No. 13618

Engineering Evaluation of the MEMCOR Small ROWPU

SUBJECT: Safety and Health Assessment of MEMTEC America Corp.,
MEMCOR Div. 3 GPM, Reverse Osmosis Water Purification Unit (ROWPU),
Serial No. 5048, built for USAF STRATCOM

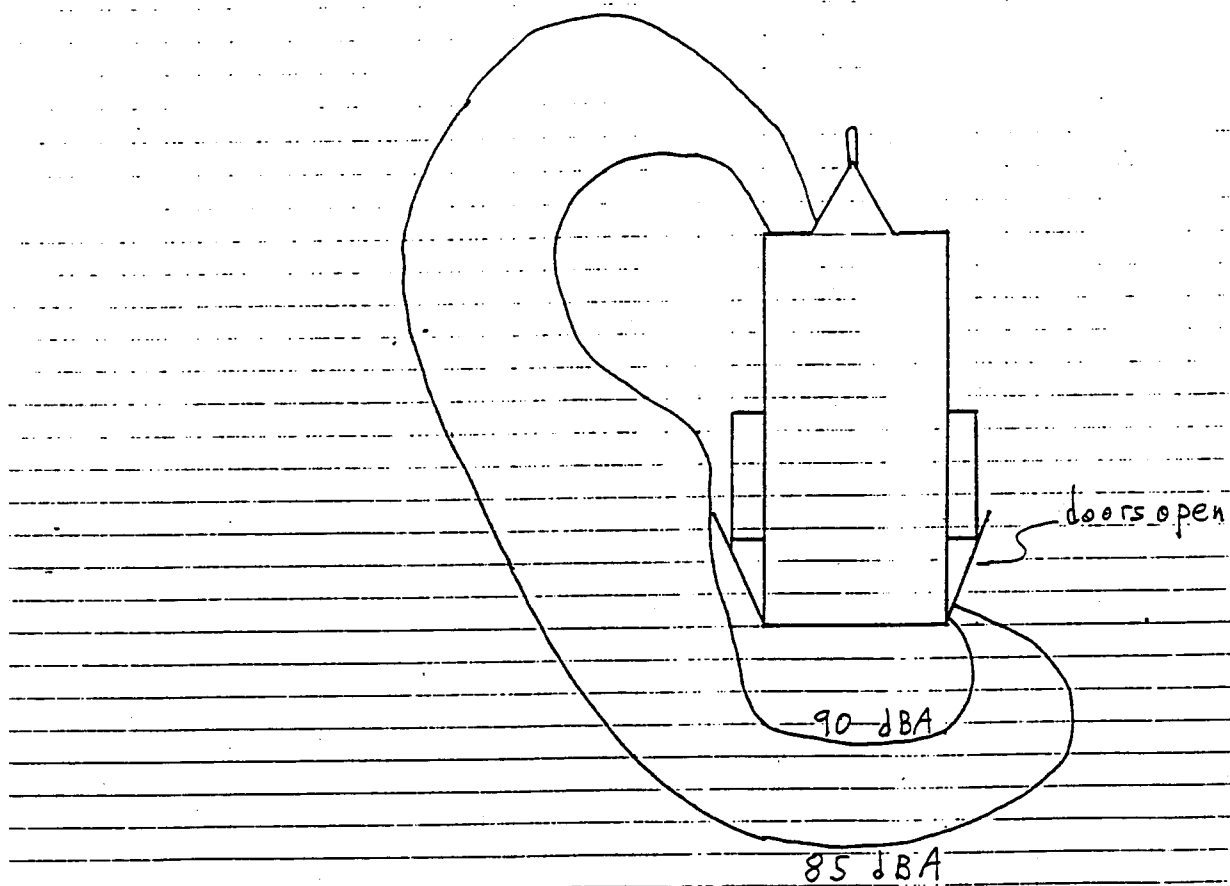
a. Exterior noise levels of 85 dBA extend a maximum distance of 11 feet 6 inches from the exterior of the trailer with all doors open. For 85 and 90 dBA noise contours, see Encl 1.

Figure 1. Display heights. This front view sketch is not to scale. The generator gauges are directly above the meters and switches deep under the RO vessels.

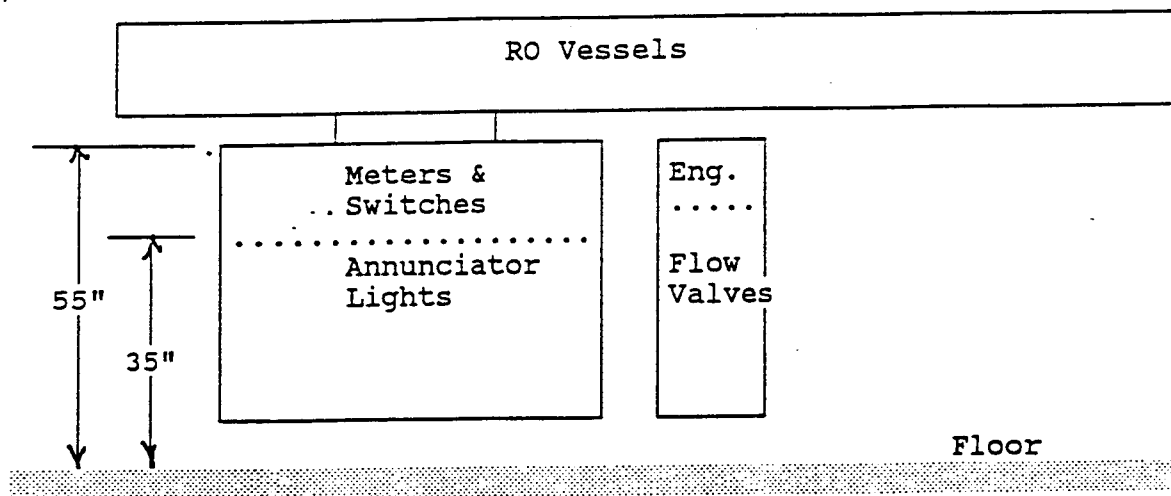
m. Controls are not located at eye height (see Figure 1). The engine portion is not labeled properly. Illumination on the control panels is wholly insufficient and poorly distributed. The generator meters are buried under the Reverse Osmosis (RO) vessels and have scales that are hard

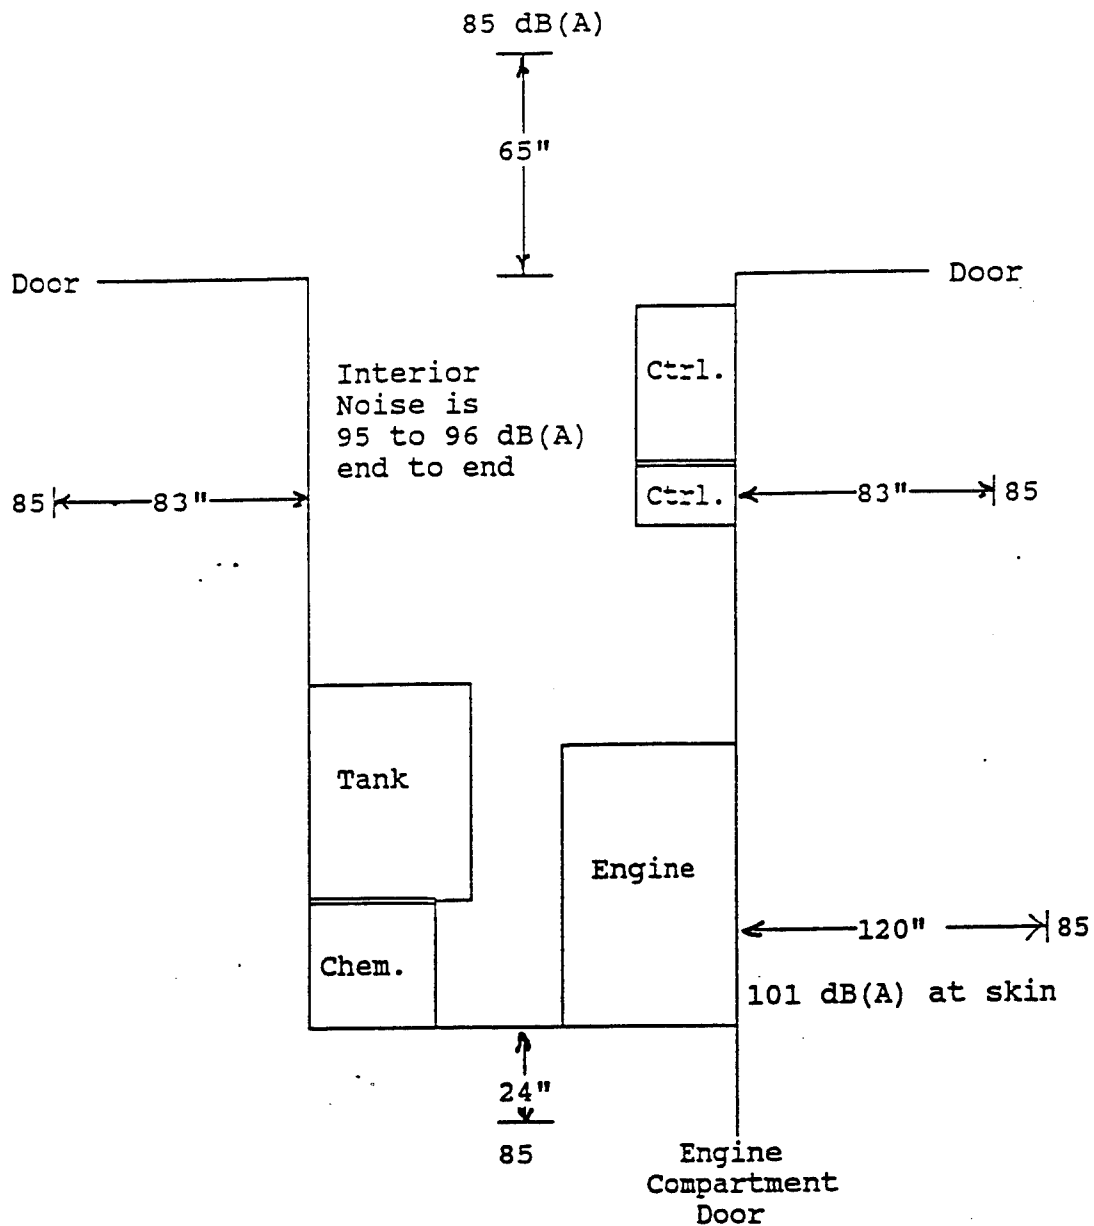
a. Figure 2. lists internal and external noise levels which vastly exceed MIL-STD-1474C (Tri-Service) requirements. Interior levels of 95 to 96 dB(A) cause a 23% hearing damage risk level. Exterior levels also exceed the commonly required 85 dB(A) at 1 meter level. Hearing damage hazard signs are not posted. Thus, personnel are not warned of the hazard. Hearing loss compensation cost the Army more than \$2 billion since 1968. So, controlling the hazard at the source, rather than hoping that warning signs will suffice, is prudent.
